Lime Stabilization Report

1. Lime stabilization (or similar) is deemed necessary at Seacourt

Lime stabilized reservoir wall 1

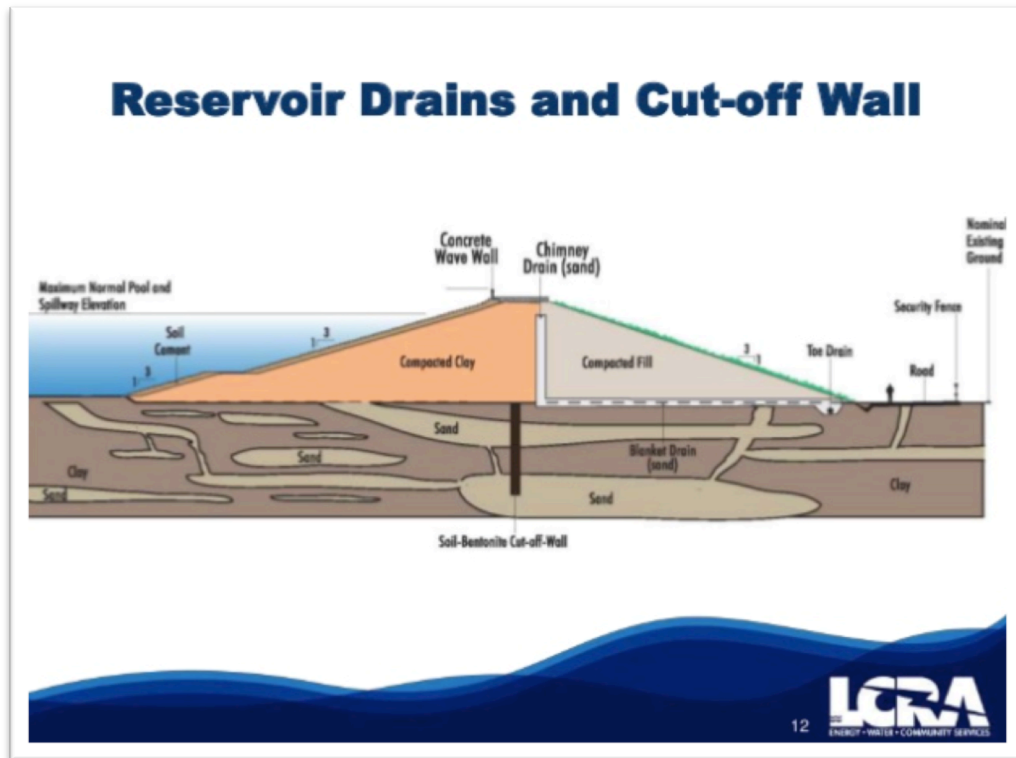
Lime stabilization is used to create barriers that are impermeable to water, for instance in the creation of reservoirs, as these photographs from the Lane City Reservoir, Texas, demonstrate:
